Docket Item # 14
BAR CASE # 2008-0100

BAR Meeting
July 9, 2008

ISSUE: Demolition/Encapsulation

LOCATION: 212 Wilkes Street

Figure 1: Plat

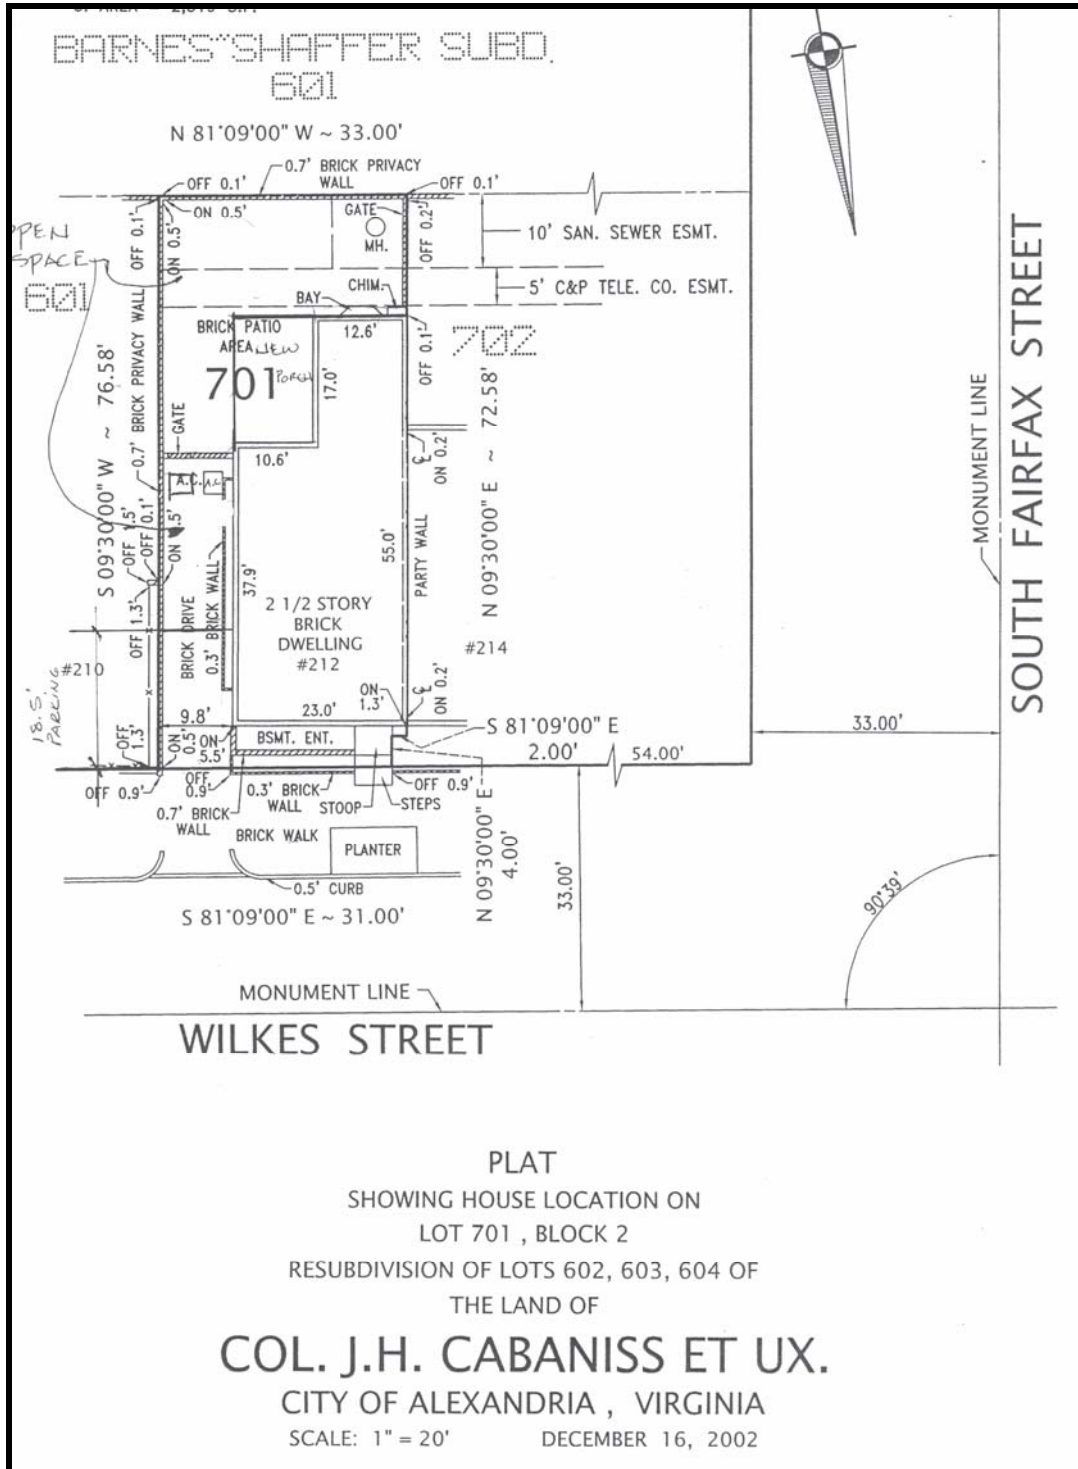
The applicant is requesting approval of a Permit to Demolish/Encapsulate in order to construct a screened porch addition at 212 Wilkes Street. The southeast corner of the house will be encapsulated and a 7' portion of the east wall will be demolished in order to construct a small 4' by 7' addition which will project into the screened porch volume. A shed on the property is also proposed to be demolished as part of the project.

In the opinion of Staff, none of the above criteria are met. This is a late-20th century townhouse and the demolition/encapsulation is very minimal in scale with limited visibility. The shed

appears to date from after the construction of the house in 1972, with only the top foot of the shed is visible above the existing brick wall. Therefore, Staff recommends approval of the application as submitted.

Staff recommends approval of the Permit to Demolish/Encapsulate as submitted.
